IMU BOARD

DIGITAL SHARK TECHNOLOGY		
Title: Cover Page		
Size: A	Document Number: 1.0	Rev: 1.1
Date: Thursday, November 13, 2025	Sheet 0 of 4

RIBBON CONNECTOR

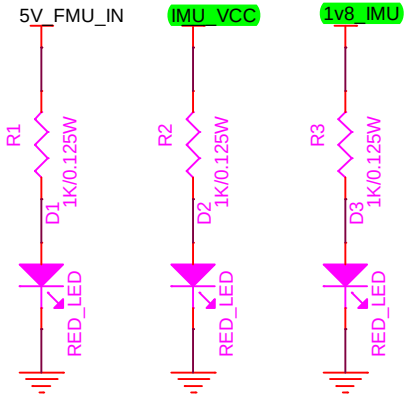
Check the Orientation of connector Mounting.

3.3V LDO IMU

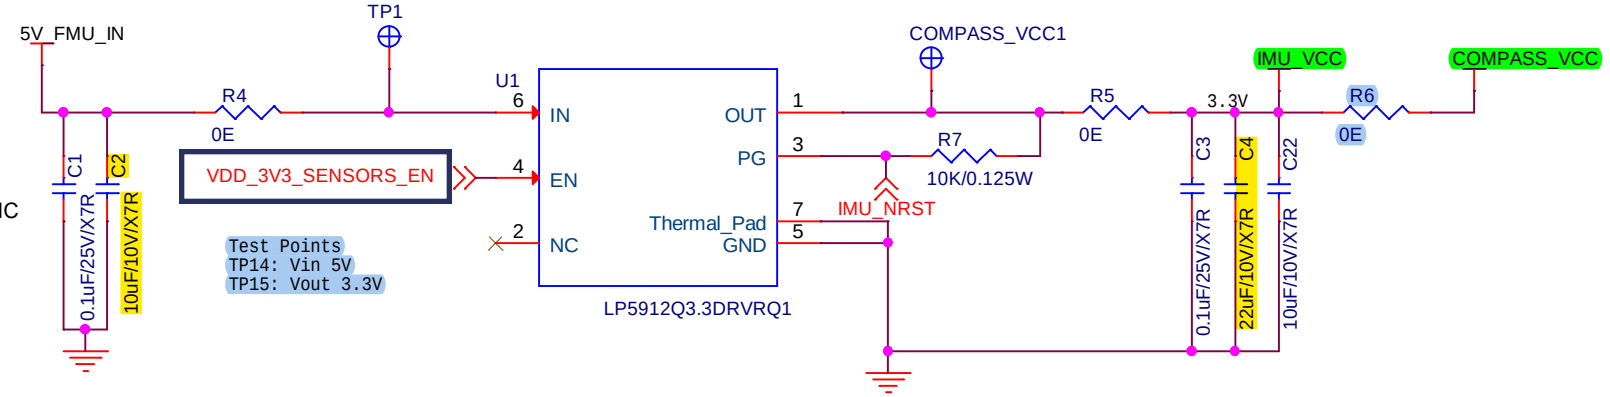
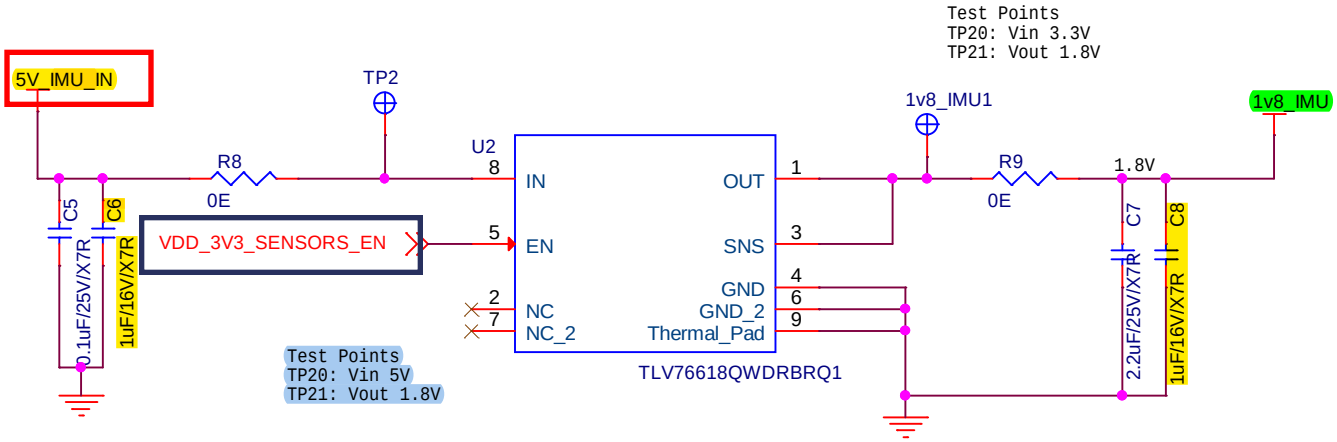
Remove R6- during Board bring-up

0E = Resistors to be removed - after the capacitors

Net name is wrong.

"5V_IMU_IN" to be changed to

"5V_FMU_IN"

MS5611-BAROMETER

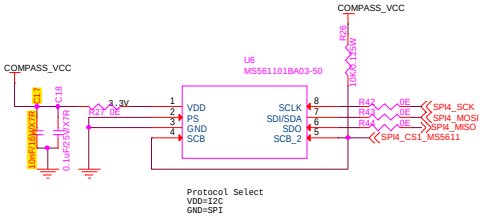
Remove R31- during Board bring-up

BMM350-MAGNETOMETER

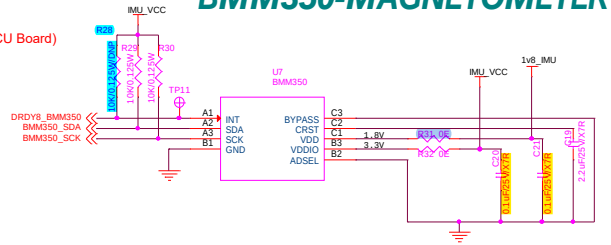
R29, R30 to be removed
(Already Pull-up resistors added in FCU Board)
